Service Bulletin

Bulletin No.: 12-02-32-001A

Subject: Hydraulic Power Steering Leak at Hose Connection to Steering Rack

Models: 2007-2013 Cadillac Escalade Models
2007-2013 Chevrolet Avalanche, Silverado, Suburban, Tahoe
2007-2013 GMC Sierra, Yukon Models

2760840

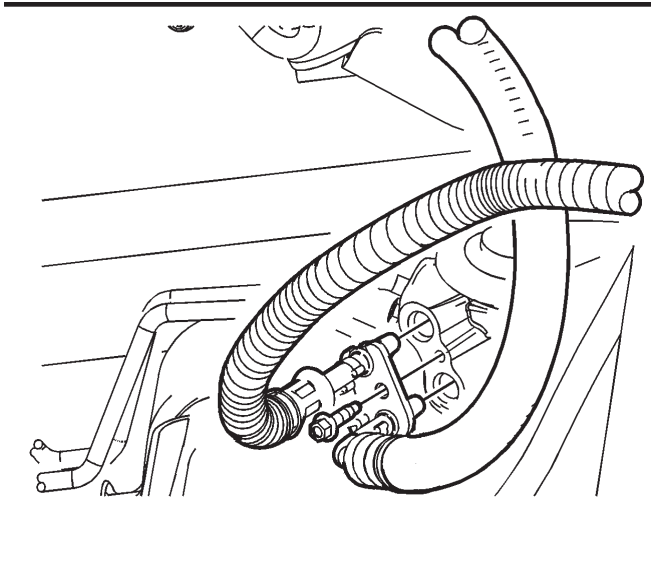
Some customers may comment on a fluid leak under the front of the vehicle. Upon further investigation, the technician may find fluid leaking from the power steering hose connection at the rack.

Based on parts returned to the Warranty Parts Center (WPC), replacement of both hose-to-rack “duckbill type” seals has corrected the condition. Replacement of the rack is not necessary for this issue.

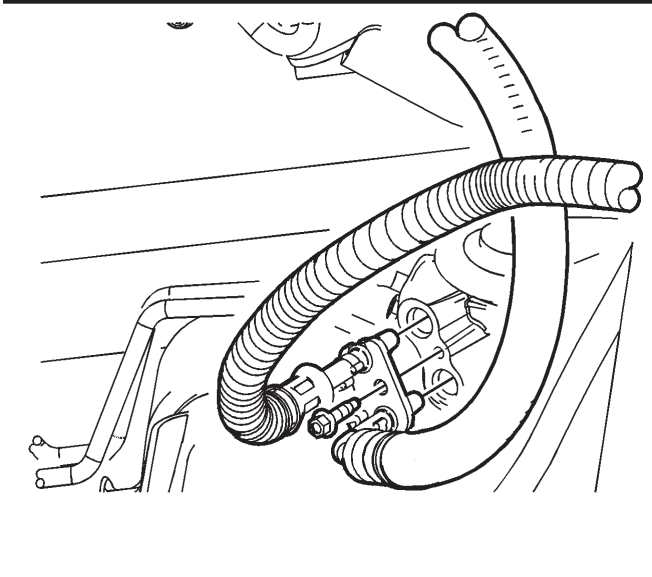
1. Start diagnosis by inspecting the fluid level in the power steering reservoir. If the fluid level is NOT low, a careful analysis of the condition is necessary as it may involve a different type of fluid leak.
2. Visually inspect the area where the hose connection occurs.
3. Before the next step, check the bolt securing the hoses to the steering gear for proper torque (12 N•m or 126 lb in).
4. Clean the area around the connections, joints and seals with engine degreaser or equivalent.
5. Add fluorescent dye (such as Kent Moore GE 28431-6) to the power steering fluid.
6. Start the vehicle and allow the power steering system to reach normal operating temperatures.
7. Turn the steering wheel to the stops in each direction while bumping the steering wheel against the stops 3-4 times. This will build maximum steering system pressure and help identify the source of the leak if present.

8. Verify the source of the leak is actually the hose connection to the power steer rack.
9. If the source of the leak is from the hose to power steering rack connection, remove the bolt securing the hoses and replace the seals to correct the leak. Replacement of the power steering rack is not necessary to correct the condition.

2760840

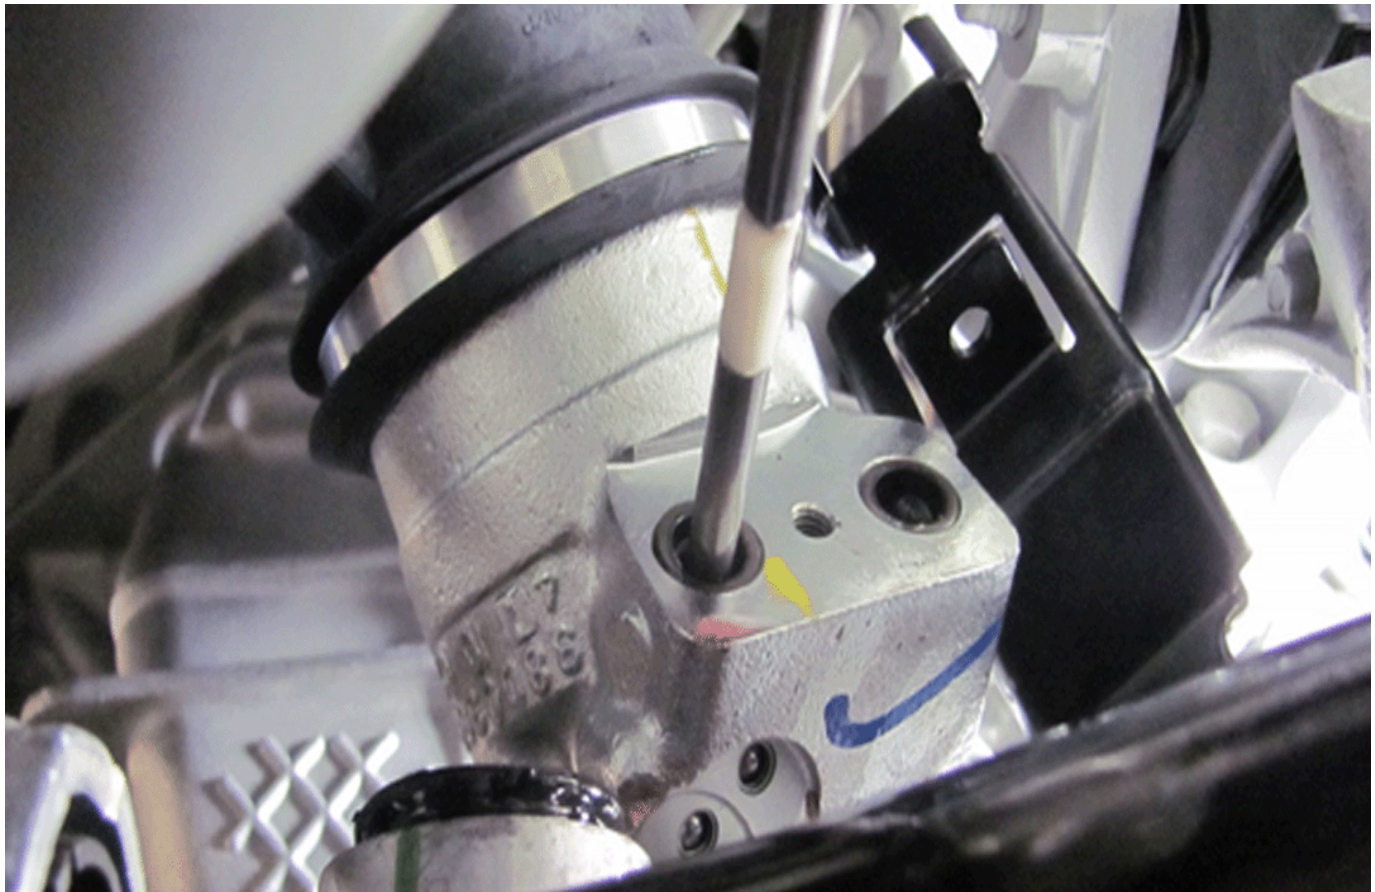
1. If not already done, remove the chip cover from the truck frame, exposing the hose/gear connection.
2. Remove the bolt fastening the connector plate to gear housing using an 8 mm hex socket and ratcheting socket wrench.
3. Grasp the hose tubes, one in each hand, and pull out from the connection, wiggling slightly as you pull back.

4. If the seals remain in the gear housing, remove them using the Kent Moore J-42640.
- Tip:** Do not utilize a screwdriver or any other sharp ended tool to remove the seals since such a tool could damage the housing bore.

5. Wipe the gear housing plate connection surface clean of oil and any debris. Place the replacement seal, P/N 26100863, in the counterbore and seat using the J-42640. Tap into place until the seal is firmly against the bottom of the counterbore. Do this for both ports.

6. Grasp the hose tubes and align to the ports. Insert the tube ends until you feel them "snug-up" in the seals. (Note: there will be a gap between the connection plate and the gear housing.) Do not allow the tube ends to come back out of the housing ports.
7. Align the connection plate bolt through the hole in the connection plate. Insert the bolt to the gear housing threaded hole and hand start.
8. Drive the bolt into the housing the remainder of the way utilizing the hex socket and ratcheting wrench. This will draw the hose tube ends into the ports and seat the connection plate.

Tighten the bolt to 12 N•m (106 lb in).
